State of Alaska
Department of Environmental Conservation
Village Safe Water Program

Re: Amendment 1
ITB 23-VSW-MCG-021
McGrath Artic Pipe and Fittings for Wastewater Improvements
ITB Due Date: April 25, 2023 @ 2:00 PM AST

GRAVITY SEWER ARCTIC PIPE DETAILS

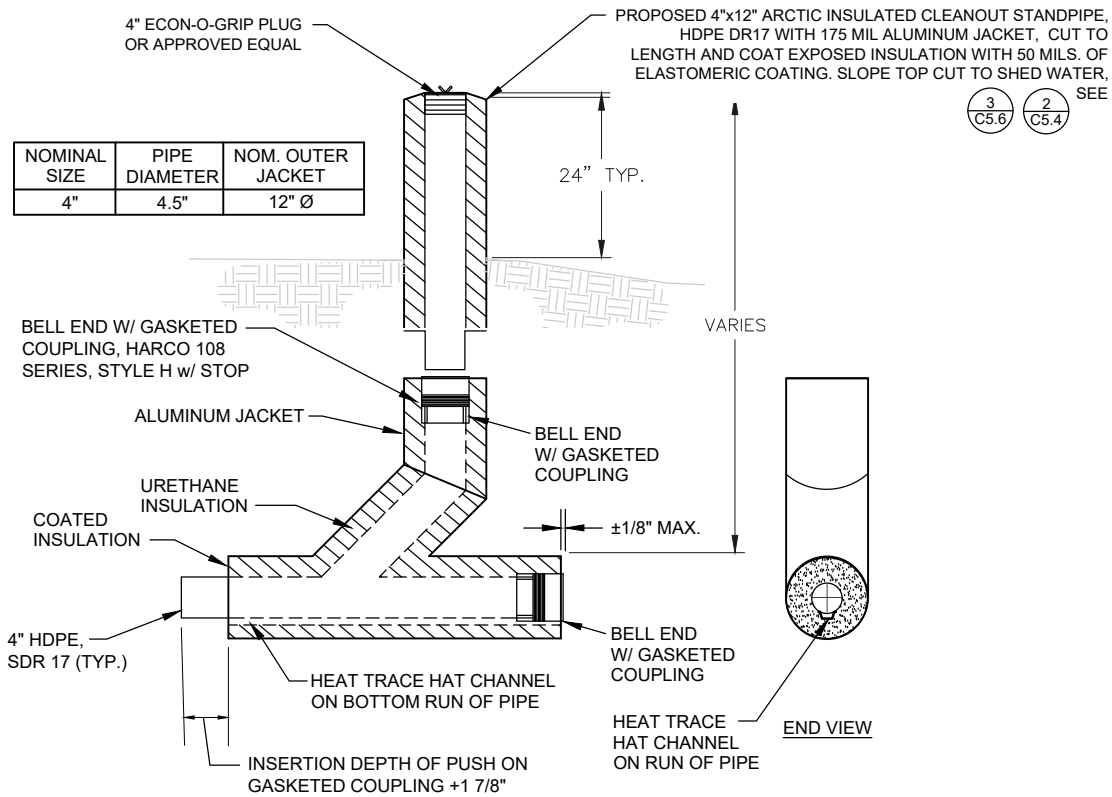
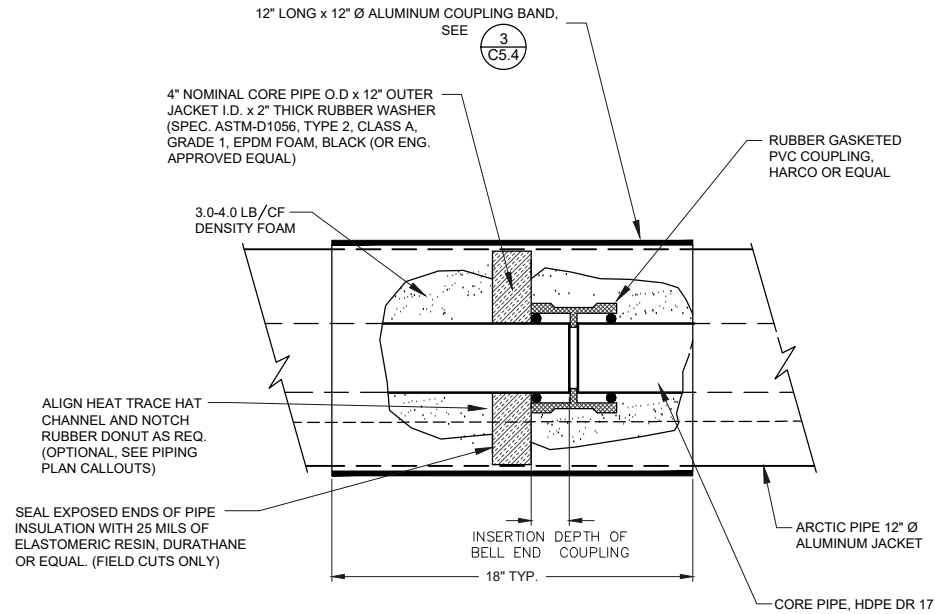
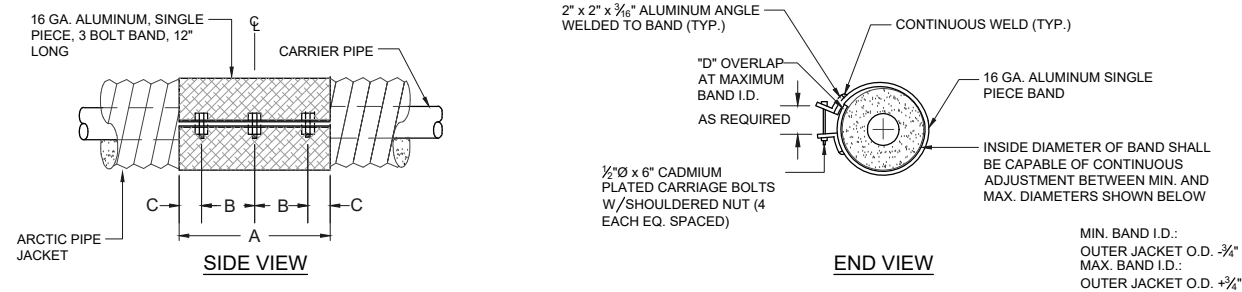
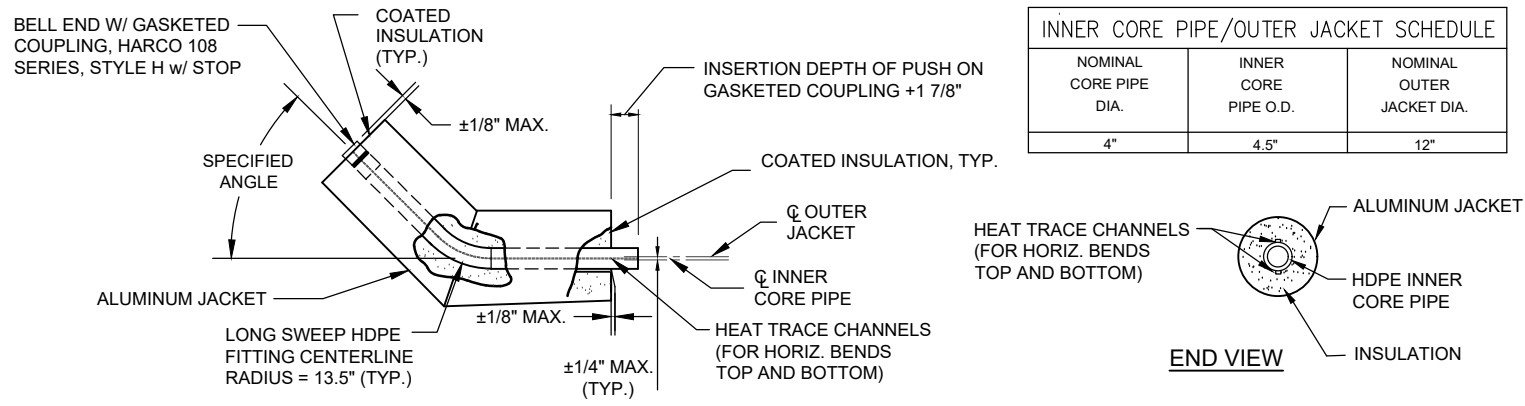
1. Vendor: Can you please provide the drawings for the insulated pipe, insulated fittings, and insulated joint kits that are referenced in the specifications?

Department: See attached Pipe Details Sheets for the insulated pipe, fittings, and joint kits that are referenced in the specifications.
